dsPIC33EPXXXGM3XX/6XX/7XX Family Silicon Errata and Data Sheet Clarification

The dsPIC33EPXXXGM3XX/6XX/7XX family devices that you have received conform functionally to the current Device Data Sheet (DS70000689D), except for the anomalies described in this document.

FIGURE 1: TIMING DIAGRAMS FOR CENTER-ALIGNED AND EDGE-ALIGNED MODES

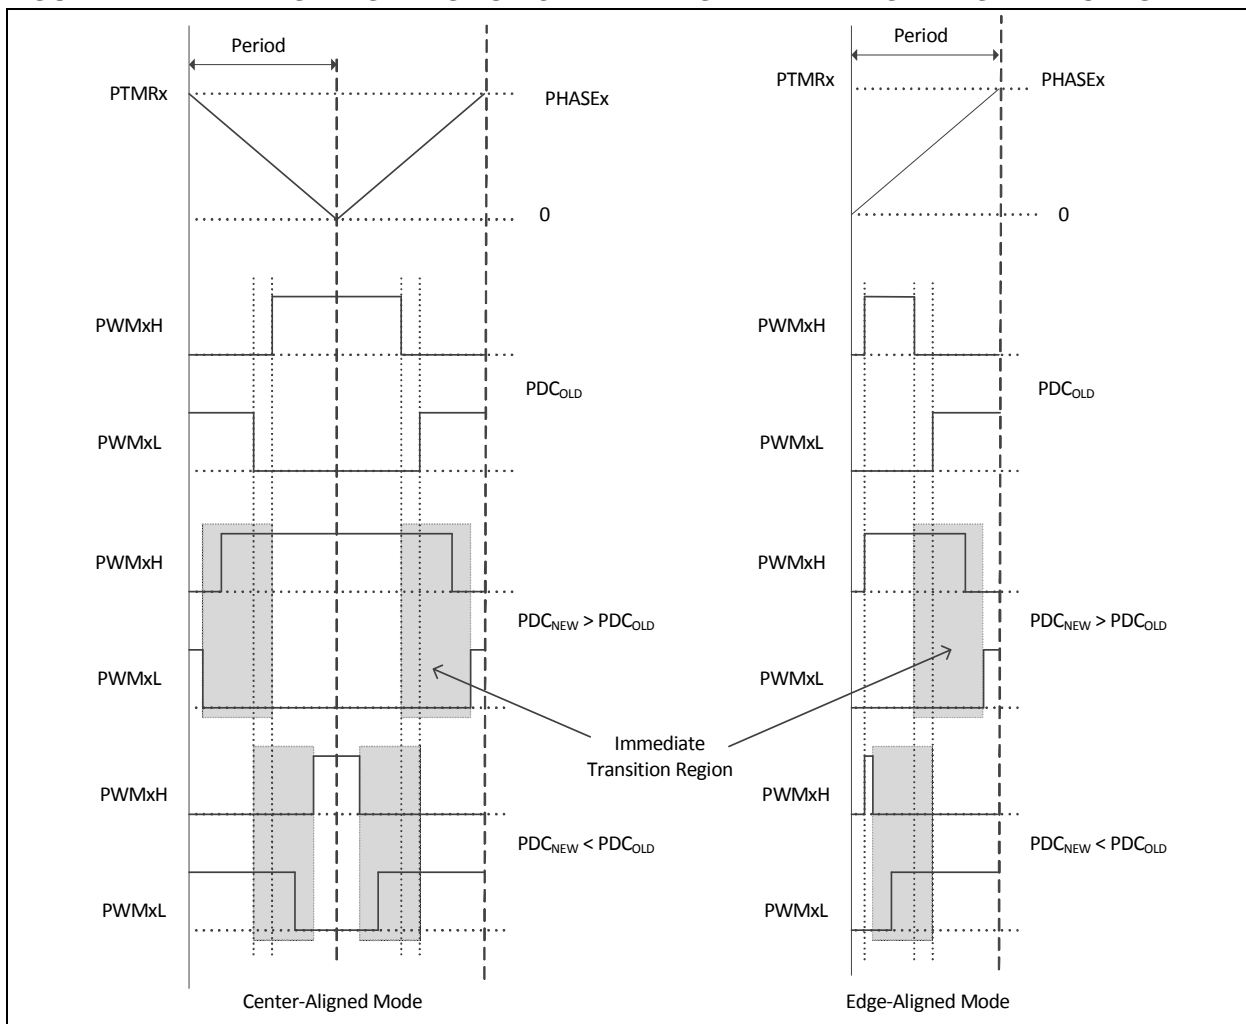
The PWM generator may not assert dead time on the edges of transitions. This has been observed when all of the following conditions are present:

- The PWM generator is configured to operate in Complementary mode with Independent Time Base (ITB) or master time base;
- Immediate update is enabled; and
- The value in the PDC register is updated in such a manner that the PWMxH and PWMxL outputs make an immediate transition.

In **Figure 1**, if the duty cycle write occurred in the shaded box, then PWMxH and PWMxL will make an immediate transition without dead time.

In most applications, the duty cycle update timing can be controlled using the TRIGx trigger, or Special Event Trigger, such that the above mentioned conditions are avoided altogether.

FIGURE 2: PWM GENERATOR TIMING DIAGRAM

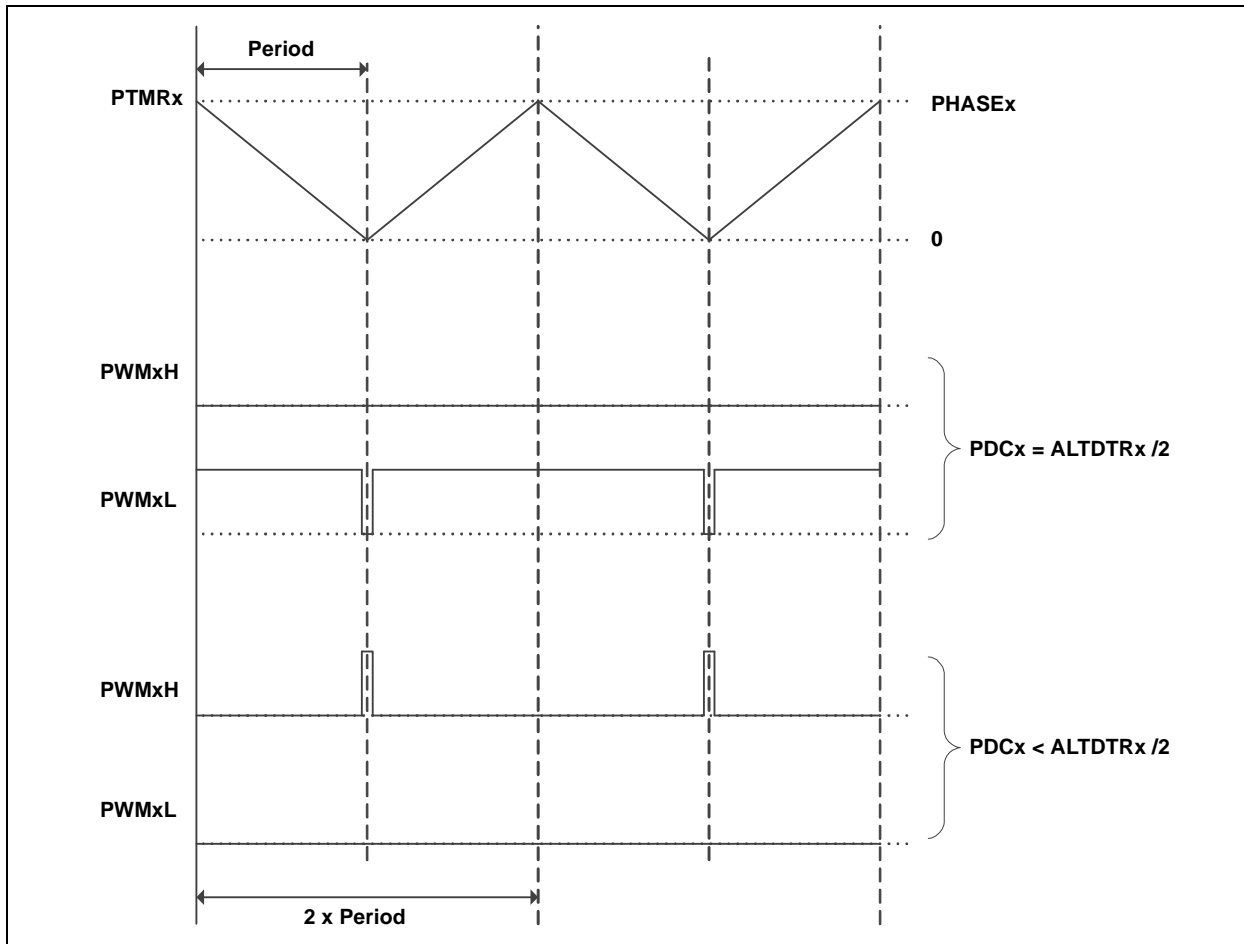
In Center-Aligned Complementary mode with Independent Time Base, if the value in the PDCx register is less than one-half the value in the ALTDTRx register, the PWM generator will force the PWMxL to low, and on the PWMxH, generates pulses of a width less than twice the dead time, as shown in Figure 2.

Include a software routine to ensure that the duty cycle value written to the PDCx register is at least one-half of the value in ALTDTRx. Example 1 shows one method, with PDCtemp representing the variable which has the value to be written to the PDCx register. Alternatively, for duty cycle values less than half the desired dead-time value, zero out the ALTDTRx register or dynamically reduce the value in the ALTDTRx register, such that ALTDTRx is always equal to $2 * PDCx$, as shown in Example 2.

FIGURE 3:

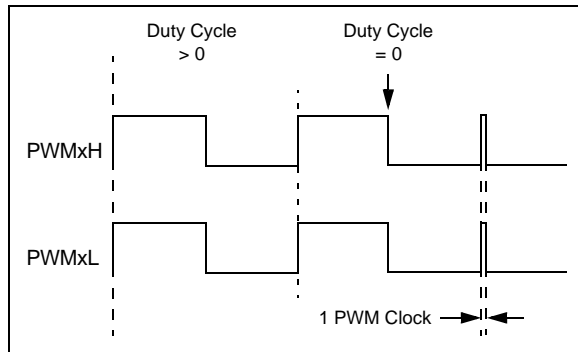
In certain output modes, the PWMx module produces a pulse glitch of one PWM clock in width (Figure 3). This has been observed only when all of the following are true:

- Either Redundant or Push-Pull Output mode is selected ($\text{IOCONx}\langle 11:10 \rangle = 10$ or 01);
- Immediate Update is disabled ($\text{PWMCONx}\langle 0 \rangle = 0$); and
- The value of the current Duty Cycle register (either the PDCx or MDC register, as determined by $\text{PWMCONx}\langle 8 \rangle$) is updated to zero from any non-zero value.

The pulse glitch has been observed to occur at the beginning of the following PWM boundary period.

If the application requires a duty cycle of zero, two possible work arounds are available.

1. Use the PWM overrides to force the output to a low state, instead of writing a '0' to the Duty Cycle register. When using this method, the PWM override must be disabled when the duty cycle is a non-zero value. If output override synchronization is configured to occur on CPU clock boundaries ($\text{IOCONx}\langle 0 \rangle = 0$), enabling and disabling the override must be timed to occur as closely as possible to the PWM period boundary.
2. Configure the module for Immediate Update ($\text{PWMCONx}\langle 0 \rangle = 1$) before enabling the module. In this mode, writes to the Duty Cycle register have an immediate effect on the output. As with the previous work around, writes to the Duty Cycle register must be timed to occur as close to the PWM period boundary as possible in order to avoid distortion of the output.

FIGURE 4:

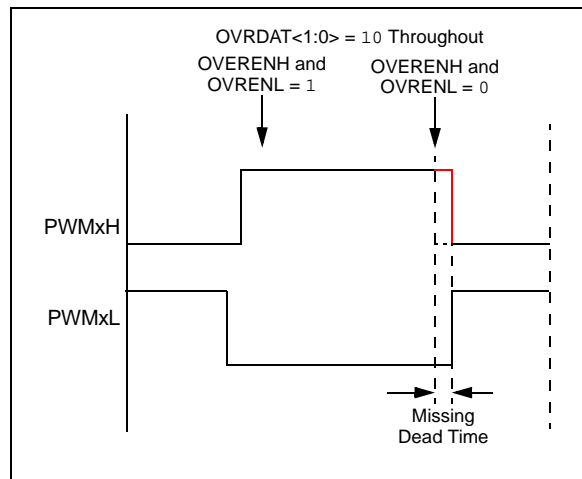
In Complementary Output mode, the expected dead time between transitions of the PWMxH and PWMxL outputs may not be asserted when the following occurs:

- Output override synchronization is configured to occur on the CPU clock boundary ($\text{IOCONx}\langle 0 \rangle = 0$);
- Both PWMxH and PWMxL overrides are enabled prior to the event (OVRENH and OVRENL are both '1'), and
- Both overrides are disabled (OVRENH and OVRENL are both '0') at the instant the dead time should be asserted (Figure 4).

This has been observed in both Center-Aligned and Edge-Aligned modes.

FIGURE 5:

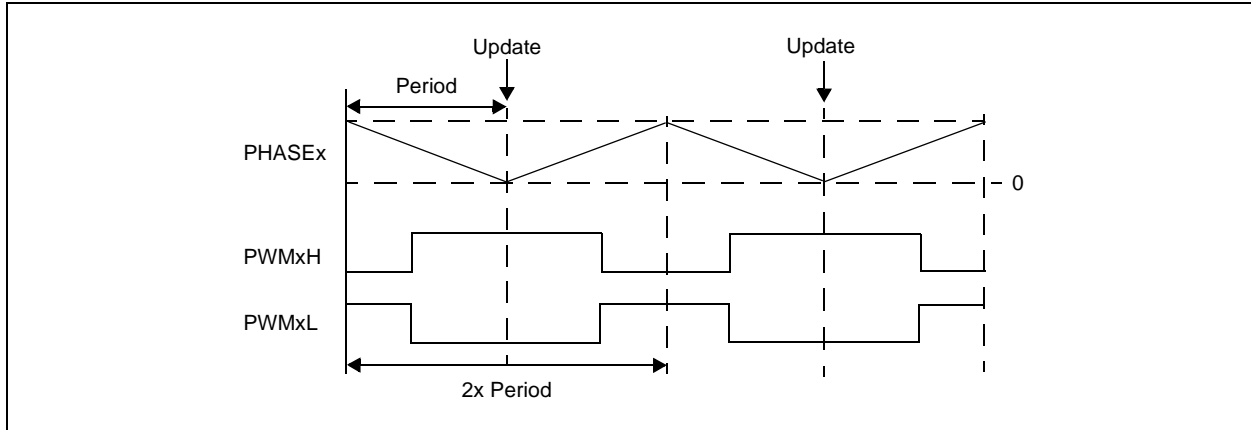
In Center-Aligned Complementary mode with Independent Time Base, updates to the PHASEx register take effect in the middle of a Center-Aligned PWM cycle, as shown in Figure 5. This occurs only when the Immediate Update feature is disabled (IUE = 0). If Immediate Update is enabled (IUE = 1), the PHASEx register updates will take effect immediately.

FIGURE 6:

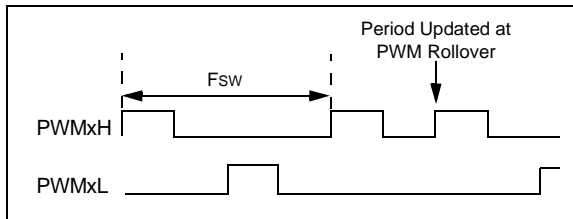
When the PWM module is configured for Push-Pull mode (IOCONx<11:10> = 10) with the Enable Immediate Period Update bit enabled (PTCON <10> = 1), a write to the Period register that coincides with the period rollover event may cause the push-pull output logic to produce back-to-back pulses on the PWMx pins (Figure 6).

Ensure that the update to the PWM Period register occurs away from the PWM rollover event by setting the EIPU bit (PTCON<10> = 1). Use either the PWM Special Event Trigger (SEVTCMP) or the PWM Primary Trigger (TRIGx) to generate a PWM Interrupt Service Routine (ISR) near the start of the PWM cycle. This ISR will ensure that period writes do not occur near the PWM period rollover event.

64-Lead Plastic Quad Flat, No Lead Package (MR) – 9x9x0.9 mm Body with 5.40 x 5.40 Exposed Pad [QFN]

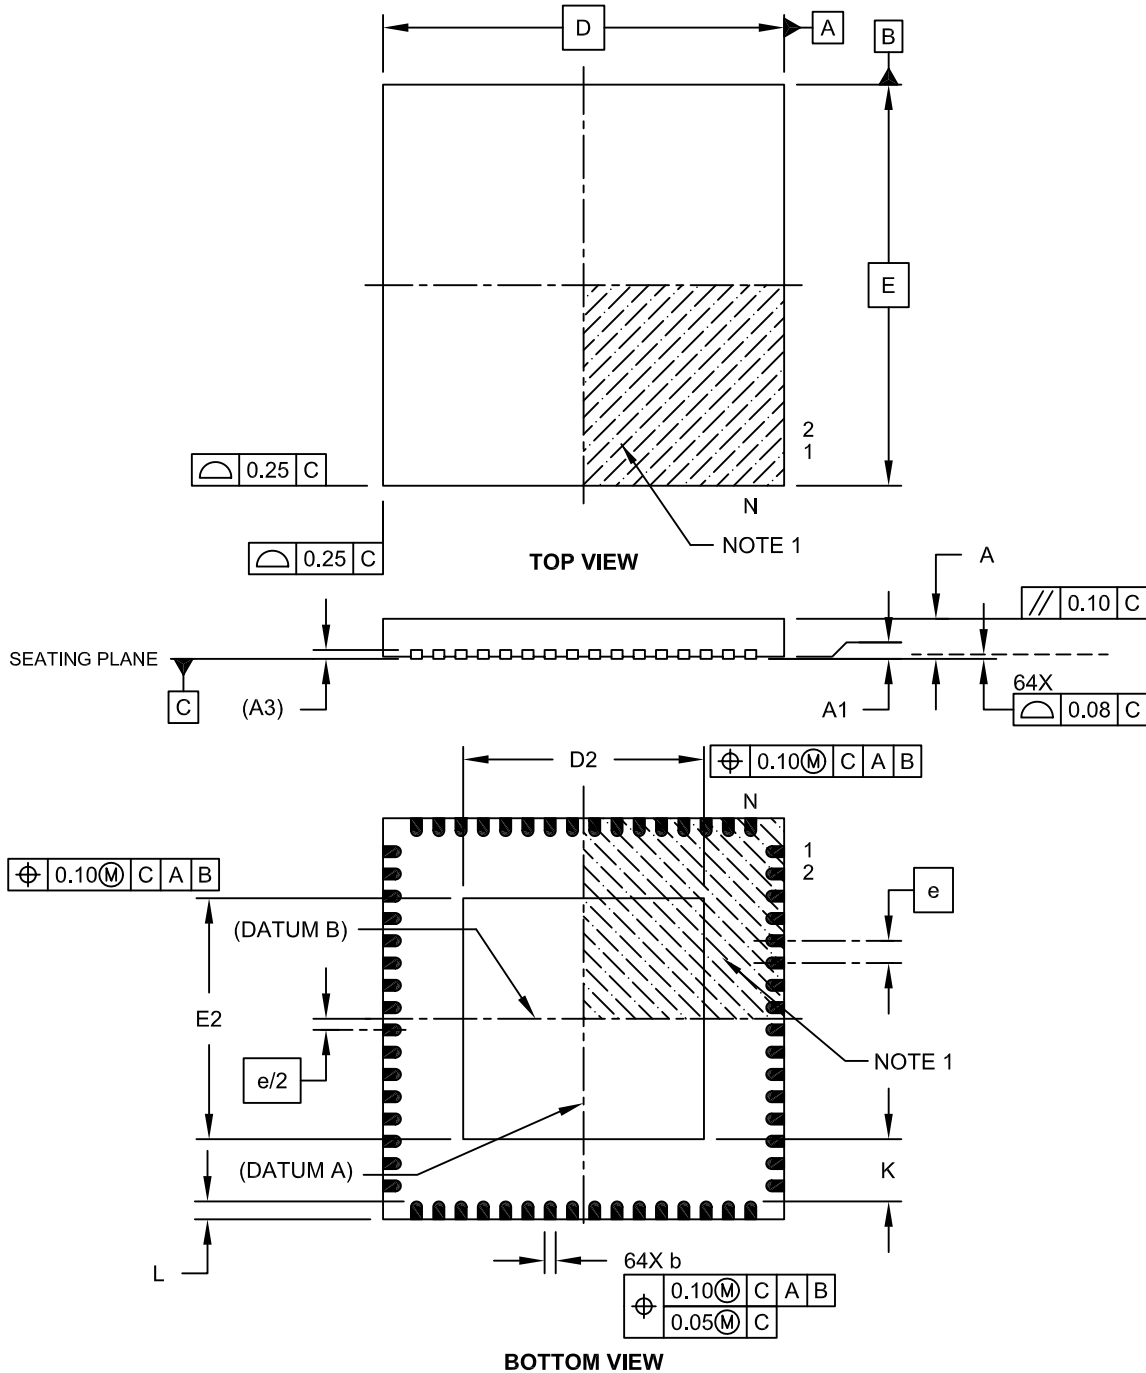
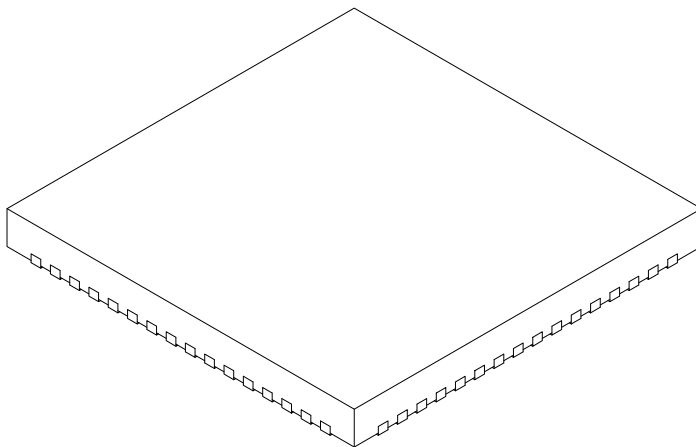
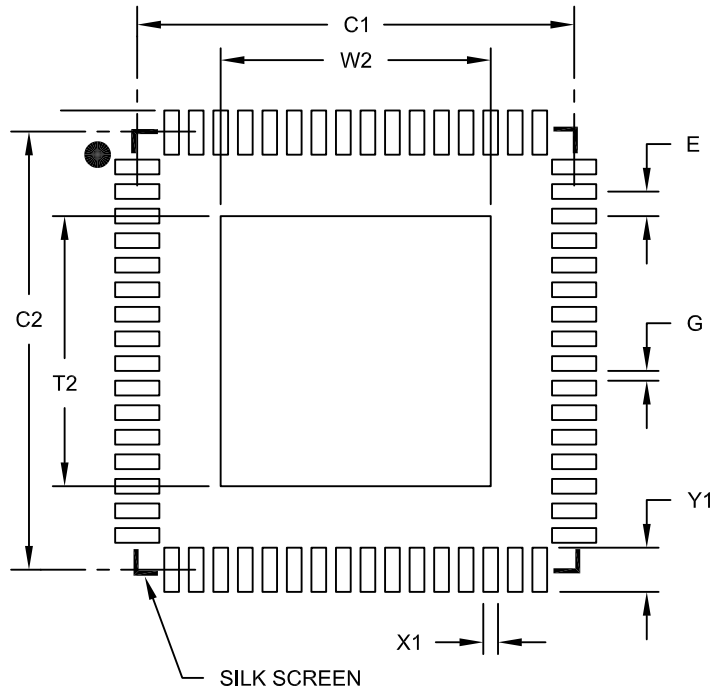
In the “*dsPIC33EPXXXGM3XX/6XX/7XX Family Data Sheet*”, **Section 35.2 “Package Details”**, dimensions for the 64-Lead Plastic Quad Flat, No Lead Package (MR) – 9x9x0.9 mm Body with 7.15 x 7.15 Exposed Pad [QFN] is mentioned. However, the dsPIC33EPXXXGM3XX/6XX/7XX family devices are not available in this package.

The dsPIC33EPXXXGM3XX/6XX/7XX family devices are available in the 64-Lead Plastic Quad Flat, No Lead Package (MR) – 9x9x0.9 mm Body with 5.40 x 5.40 Exposed Pad [QFN], and the package dimensions are shown on the following pages.
